# Access Compliance Report

## Public Rights-of-Way

### (Curb Ramps)

Intersection ID: 15736	Main Street: CHEROKEE_PL	Cross Street: LLEWELLYN_PL	Location: SE
ADA ID: 46D531EA4269	Ramp Type: PerpDiag	Initial Pass/Fail: Fail	Overall Compliance: No
Codes/Mitigation Info/Possible Solution		Field Measurements/Component Compliance	
Severity Score: 21.25

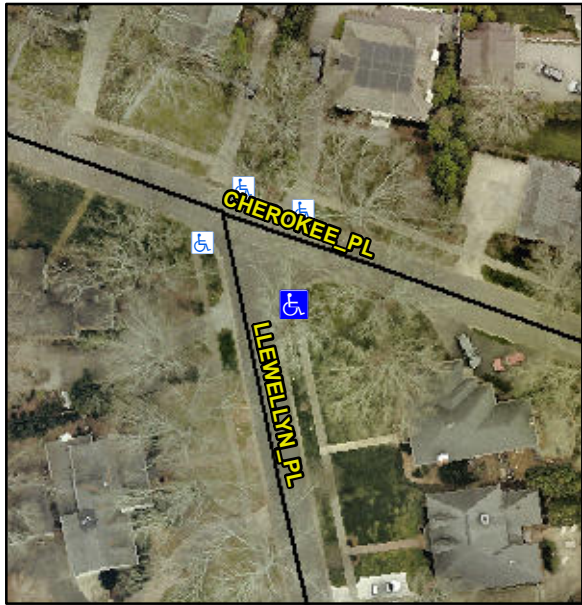
PROW/ADA:

R304.5.1, R304.2.2

Compliance	Description	Data	Compliance	Description	Data
N/A	Ramp Length (in)	58.0	No	Ramp Slope (%)	9.1
No	Ramp Width (in)	44.0	Yes	Ramp XSlope (%)	1.3
N/A	Flare Type LT	N/A	N/A	Flare Type RT	N/A
N/A	Flare Slope LT (%)	N/A	N/A	Flare Slope RT (%)	N/A
N/A	Flare Traversable LT?	N/A	N/A	Flare Traversable RT?	N/A
N/A	Landing Length (in)	N/A	N/A	DWS Provided?	N/A
N/A	Landing Width (in)	N/A	N/A	DWS Contrast?	N/A
N/A	Landing Slope (%)	N/A	N/A	DWS Length (in)	N/A
N/A	Landing X Slope (%)	N/A	N/A	DWS Full Width?	N/A
N/A	Landing Curb? (Y/N)	N/A	N/A	DWS Offset (in)	N/A
N/A	Shared Landing?	N/A			
N/A	Gutter Ponding?	N/A	N/A	Gutter Slope (%)	N/A
N/A	Gutter Lip Ht (in)	N/A	N/A	Gutter X Slope (%)	N/A
N/A	Painted X Walk1?	No	N/A	Painted X Walk2?	No
	X Walk 1 Direction	To N		X Walk 2 Direction	To NW
N/A	X Walk 1 Width (in)	N/A	N/A	X Walk 2 Width (in)	N/A
	X Walk 1 Slope (%)	1.6		X Walk 2 Slope (%)	2.1
	X Walk 1 X Slope (%)	4.2		X Walk 2 X Slope (%)	0.8

Remove & Replace Curb Ramp With Two New Directional Ramps or Equivalent.
